PROJECT NAME	2756 CHAMBERLAND NORD ST. - ROCKLAND, ON - WINNERS ROCKLAND RFQ
PROJECT NO.	GWAL 2024-221
DATE	DECEMBER 17, 2024
ADDENDUM NO.	E1

The following additions, deletions & revisions form part of the drawings and specifications for the above referenced project:

Project/Project WINNERS FIT-OUT ROCKLAND PLAZA	Drawing Title/Title du dessin ELECTRICAL PANEL SCHEDULES
--	--

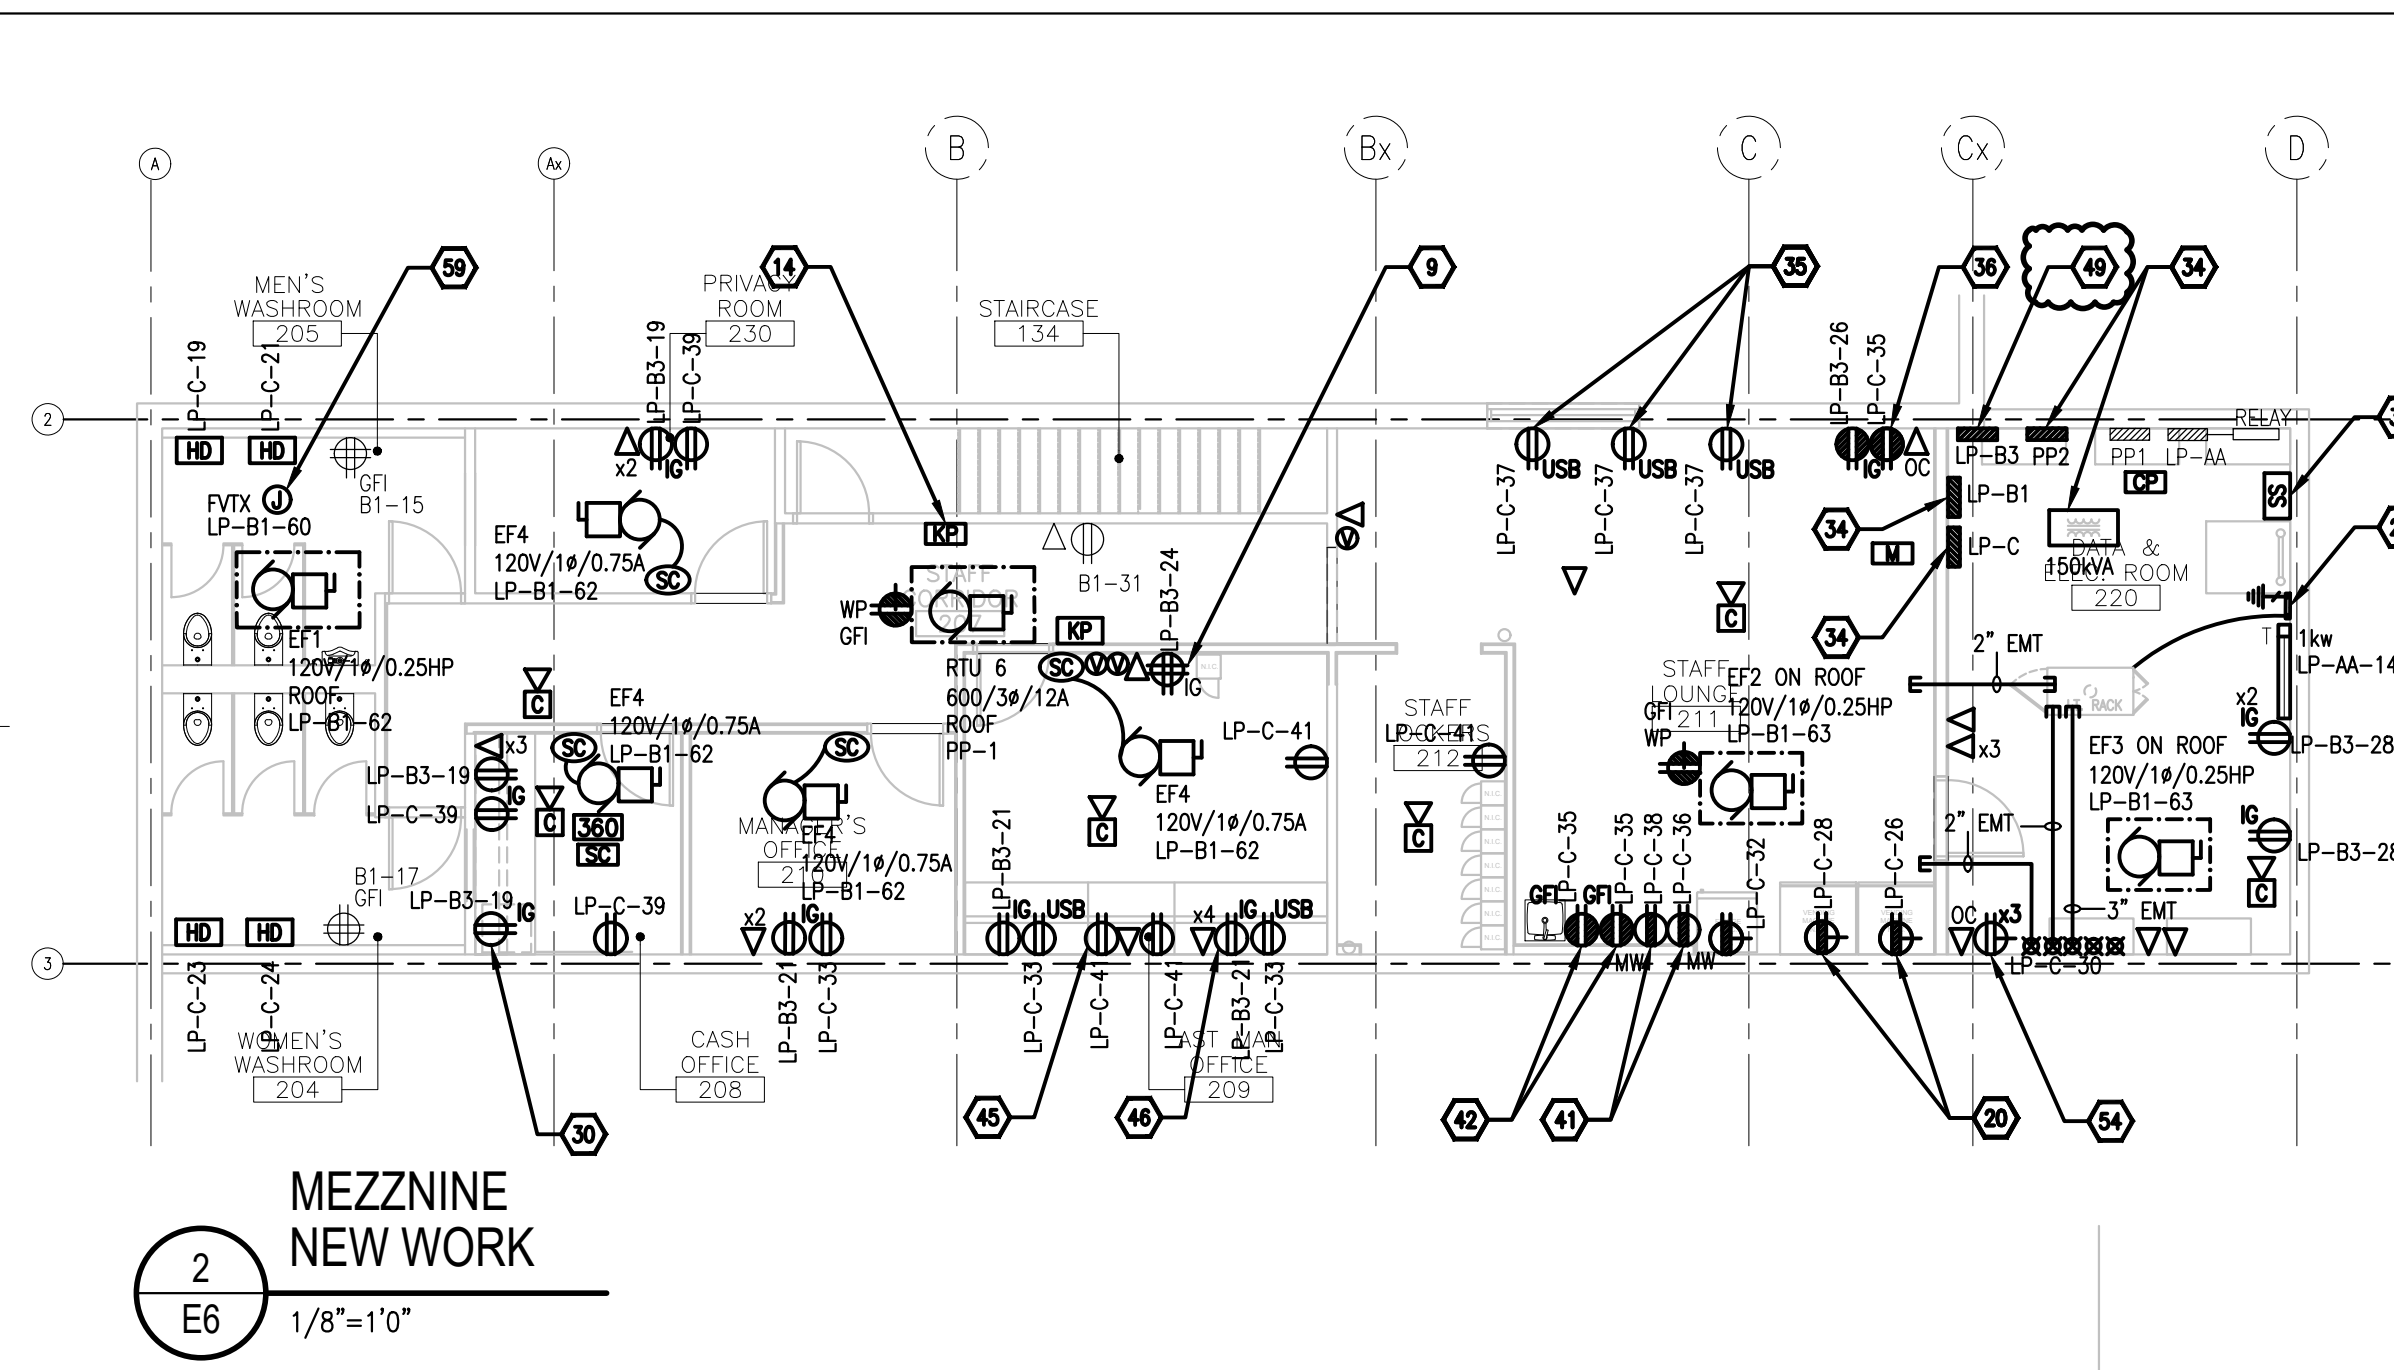
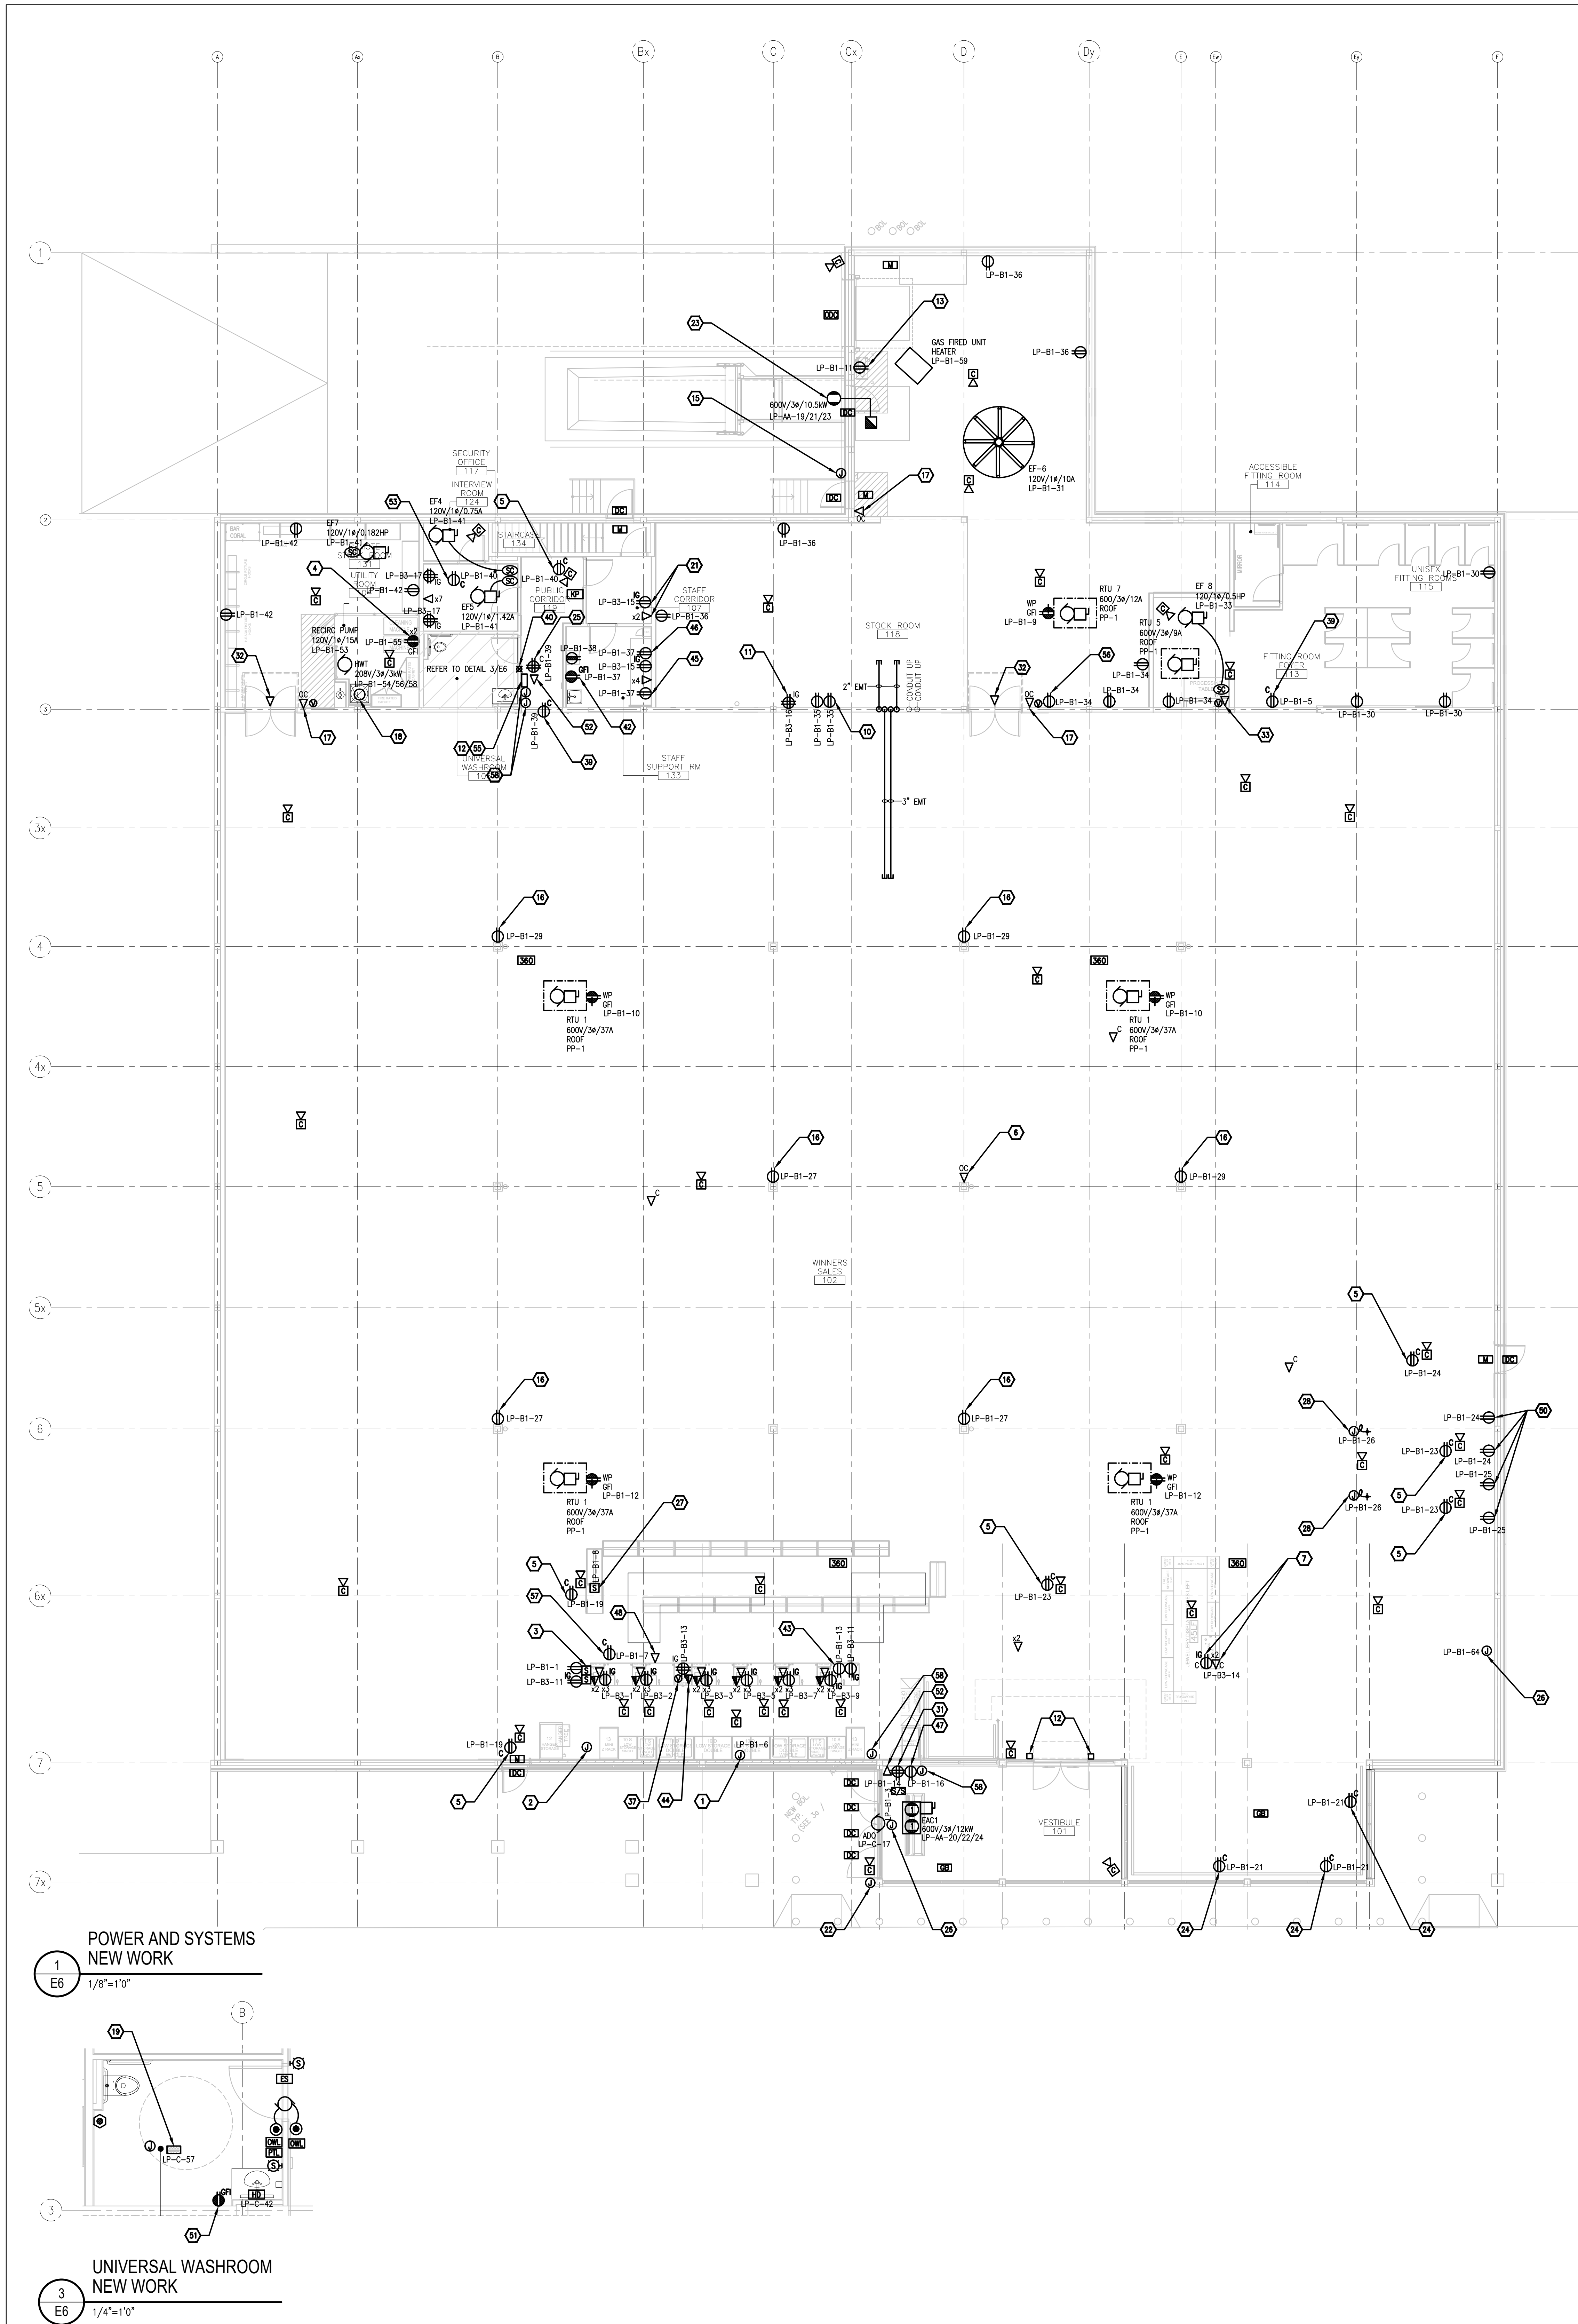
Q1: DWG E2 single line demolition indicates we are to remove 2 transformers, and 6 panels. DWG E2 single line new indicates we are to provide 1 new transformer, and 4 new panels. DWG E2 panel legends indicates that the panels are the same name and are labeled 'existing'. Are panels PP2, LP-B1, LP-B3, and LP-C new panels?

Q2: Note 1 on SLD drawing Dwg E2 request to provide new lighting contractors while EMS notes on drawing E2 indicate contractors to be supplied by EMS contractor.

Q3: SDL demolition work drawing E2 indicate primary & secondary feeder of 150kVA to be demolished while new work shows as existing, please advise.

Q4: New feeder sizes are missing on new SLD work, please provide.

2. Reference Drawing E2 issued for tender 11/14/2024 and attached updated Drawing E2:

Clarification: Refer to attached updated Drawing E2 for updated switchboard distribution.

Clarification: Refer to attached updated Drawing E2 for updated light fixture schedule.

A1: PP2, LP-B1, LP-B3 and LP-C are not new panels. They are existing panels to be relocated to make way for the new partition / new data and electrical room work.

A2: EMS systems will be provided by E.M.S. contractor and wired by electrical contractor. Electrical contractor shall coordinate with EMS contractor prior to commencing work.

A3: The 150kVa transformer will be relocated. Please see attached updated drawing E2 and new power and systems work drawing E6

A4: Please see attached updated drawing E2 for clarification and feeder sizes.
